Livestock Plaza/Sheep Barn

Addendum Issue Date: 8/8/24

The following changes, revisions, or clarifications shall be made to the drawing documents.:

SHEET: C3.1

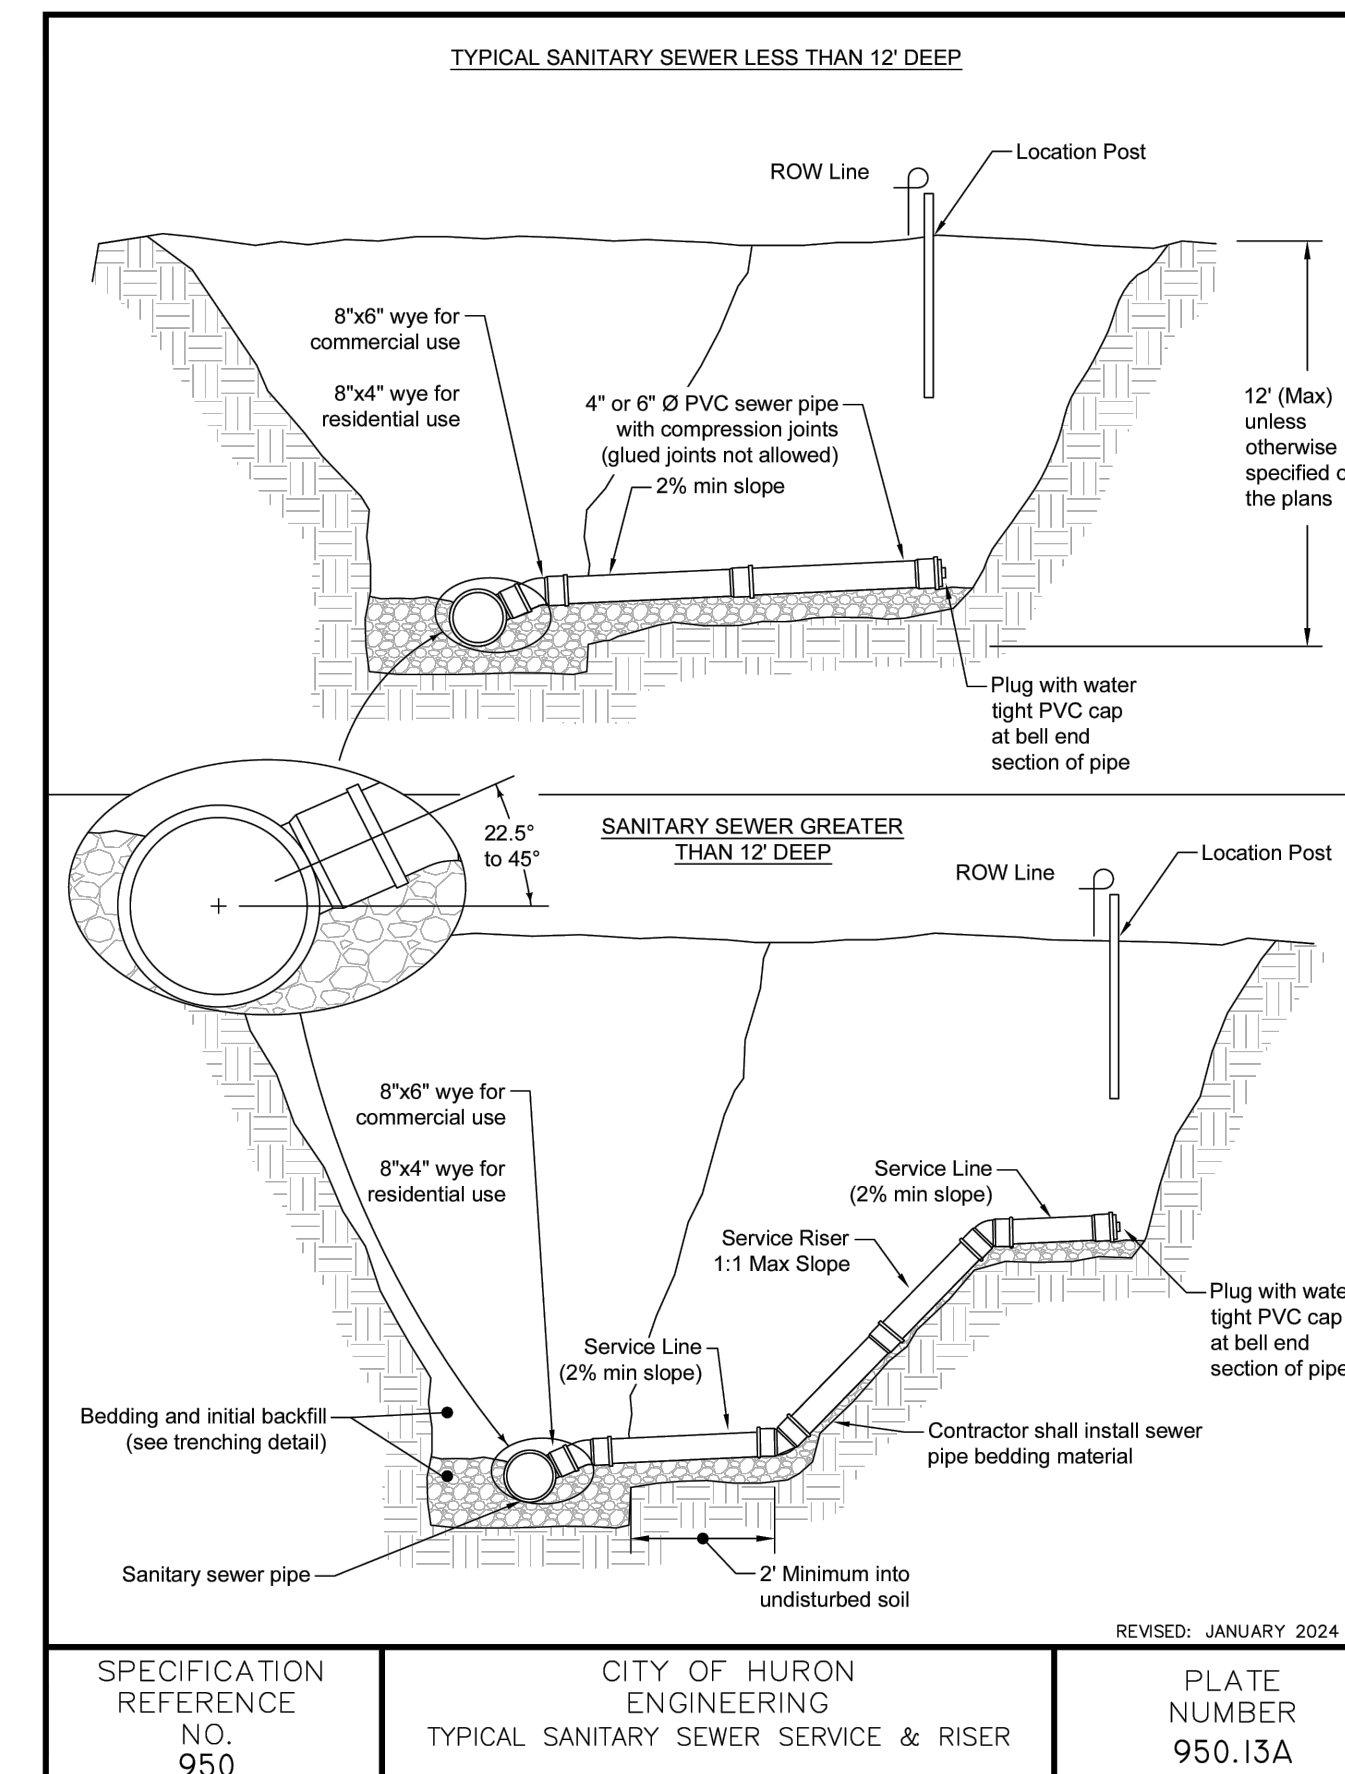
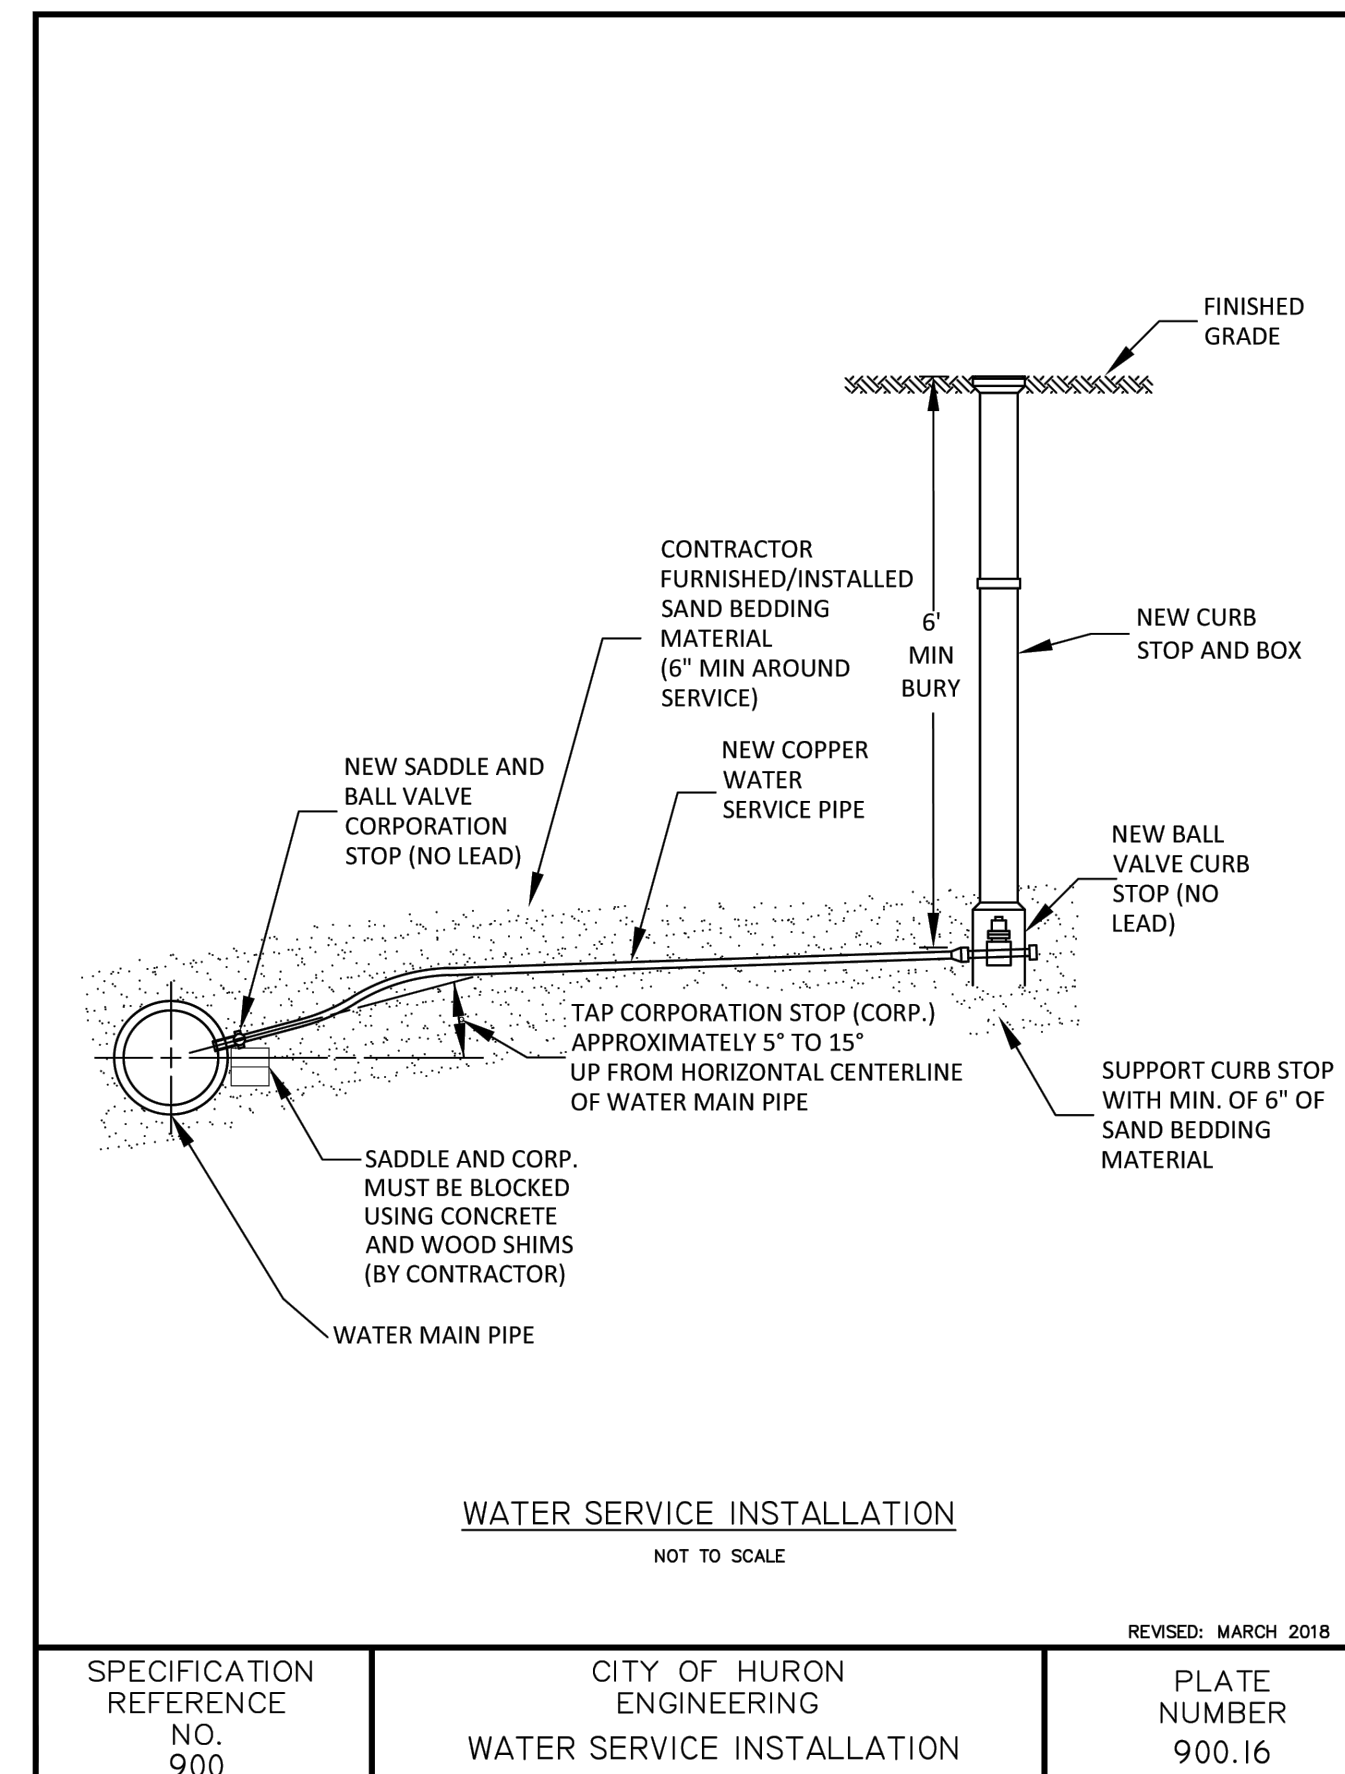
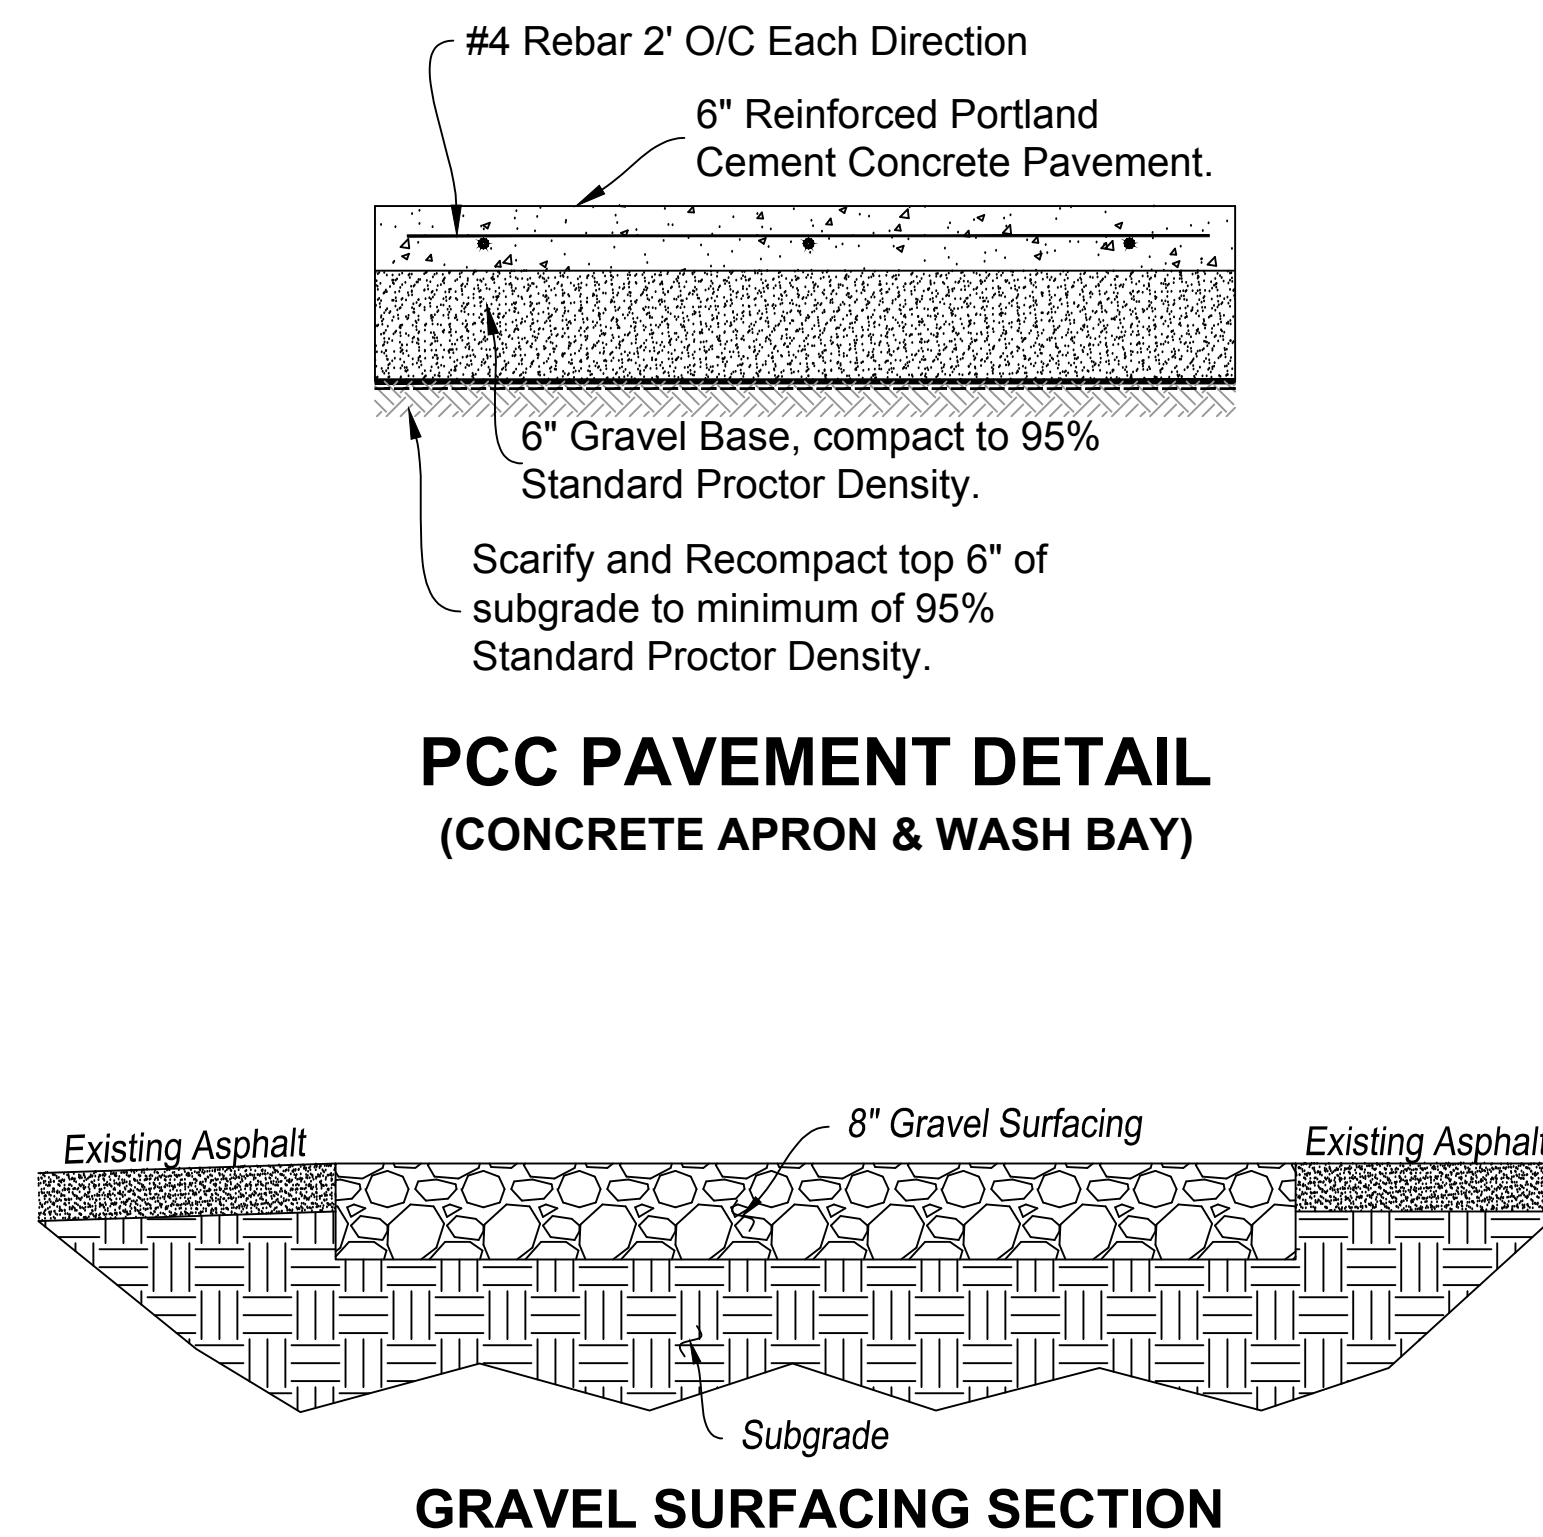
C3.1 - Quantities & Details

- Updated Quantities Tables
